PUBLIC HEARING AGENDA

**PUBLIC HEARING – 40 Unit Apartment Building + 2 Single Family Dwellings
Highland Avenue & Hillcrest Drive
(PIDs 00444885, 00444877, 30346308, 30187629)**

To: Chair and Members of Rothesay Planning Advisory Committee
From: Brian L. White, MCIP, RPP
Director of Planning and Development Services
Date: Wednesday, March 30, 2022
Subject: Rezoning - Highland Avenue & Hillcrest Drive

To: Chair and Members of Rothesay Planning Advisory Committee
From: Brian L. White, MCIP, RPP
 Director of Planning and Development Services
Date: Friday, February 04, 2022
Subject: Rezoning - 40 Unit Apartment Building – (Highland Avenue & Hillcrest Drive)

WEST ELEVATION

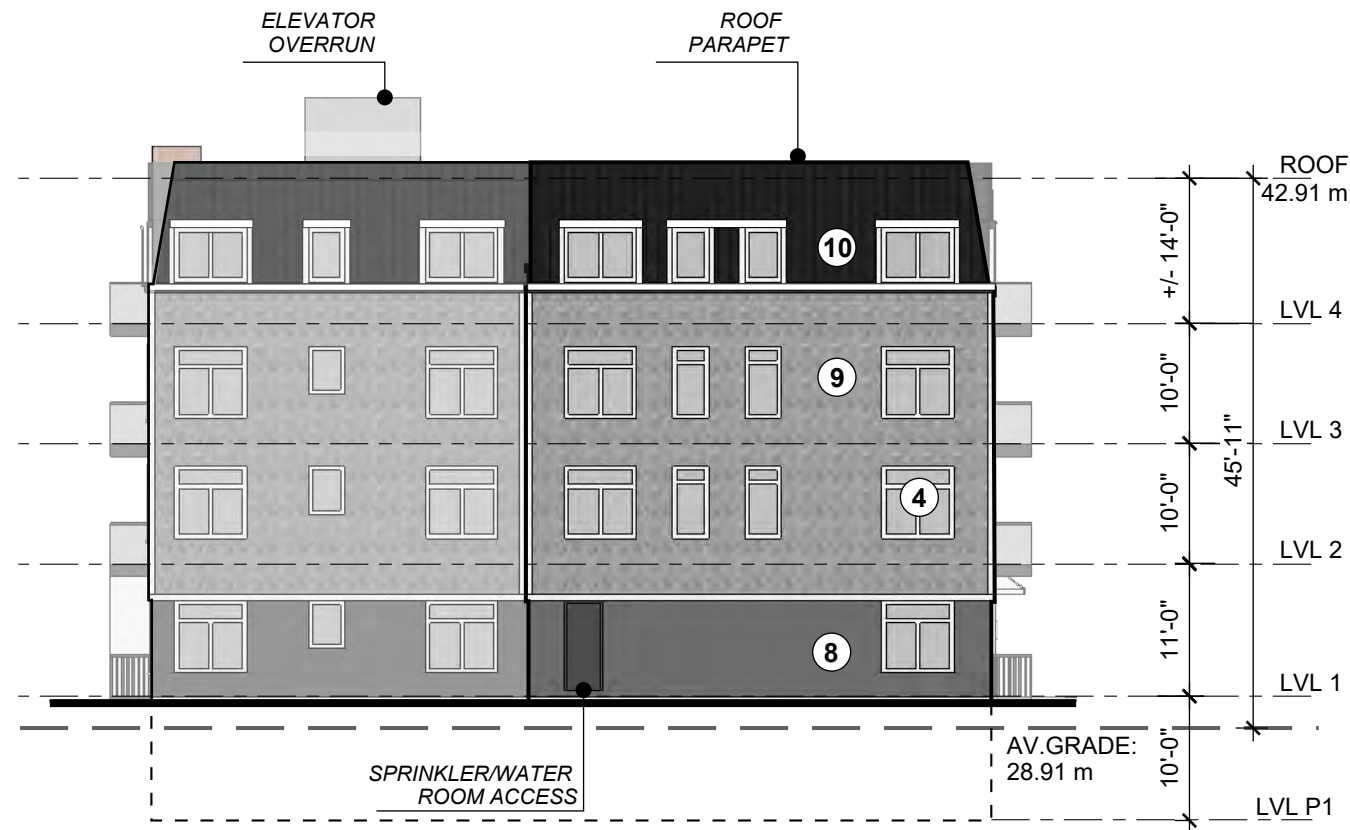
PAC directed that the applicant revise the architectural style of the project to reinforce the general character of the area. The general residential character of the area is of residential buildings with peaked roofs and of a density lower than the current proposal. The applicants revised the roof line architecture of the building. However, the roof redesign is not a peaked roof but a modified version of a Mansard Style Roof with secondary and minor roof lines. The redesign includes dormers and peaks to help break up and reduce the apparent mass of the roof and the building. Staff appreciate the attempt to modify the

1. removing the 2 single family homes (2 and 4 Hillcrest Drive) from the proposal;
2. reduce the apartment building height to 3 stories; and
3. revise the building architecture to include a peaked roof design.
